Advanced Response to

Request for Additional Information No.582, Question 15.08-1

U.S. EPR Standard Design Certification

SRP Section: 15.08 - Anticipated Transients Without Scram

Figure 15.8-1-1: Main Steam Valve Flow Rates

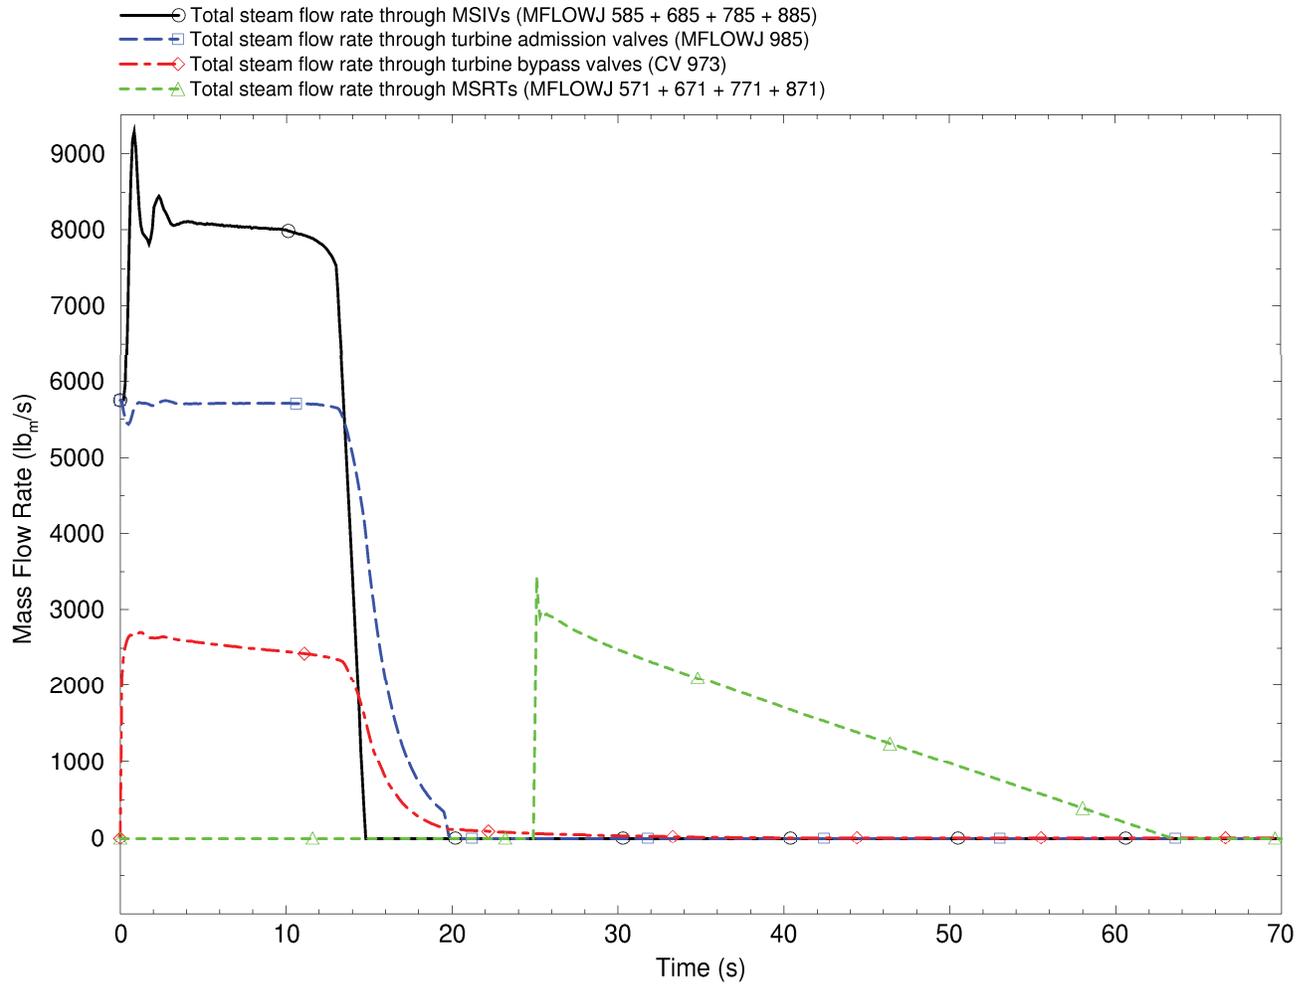
AREVA's technical report ANP-10304, "USEPR Diversity and Defense - in-Depth Assessment" lists the increase in steam flow event as an anticipated operational occurrence. Consistent with paragraph (b) of Part 50.62, (Anticipated Transients Without Scram) ATWS events are anticipated operational occurrences as defined by Appendix A of Part 50 followed by the failure of the reactor trip portion of the protection system specified in General Design Criterion (GDC) 20. The current AREVA ATWS analysis does not provide an analysis of the increase in steam flow event followed by the postulated failure of the reactor protection system to perform the necessary safety functions. Therefore, the staff cannot conclude that the EPR design meets the requirements for ATWS events set forth in paragraph (c) of 10 CFR 50.62. Provide the analysis that demonstrates compliance with paragraph (c) for the subject increase in steam flow Anticipated Operational Occurrence (AOO) or provide a basis with the appropriate exemption request that supports a conclusion that compliance with paragraph (c) is not necessary.

A sequence of events for this analysis is presented in Table 15.8-1-1. The transient is initiated at EOC full-power conditions by the inadvertent opening of five turbine bypass valves (Figure 15.8-1-1). The main feedwater flow controllers attempt to follow the increased steam flow (Figure 15.8-1-2), until the MFW control valves are wide open. With the main feedwater flow being less than the steam flow, the steam generator levels (Figure 15.8-1-3) begin to decrease.
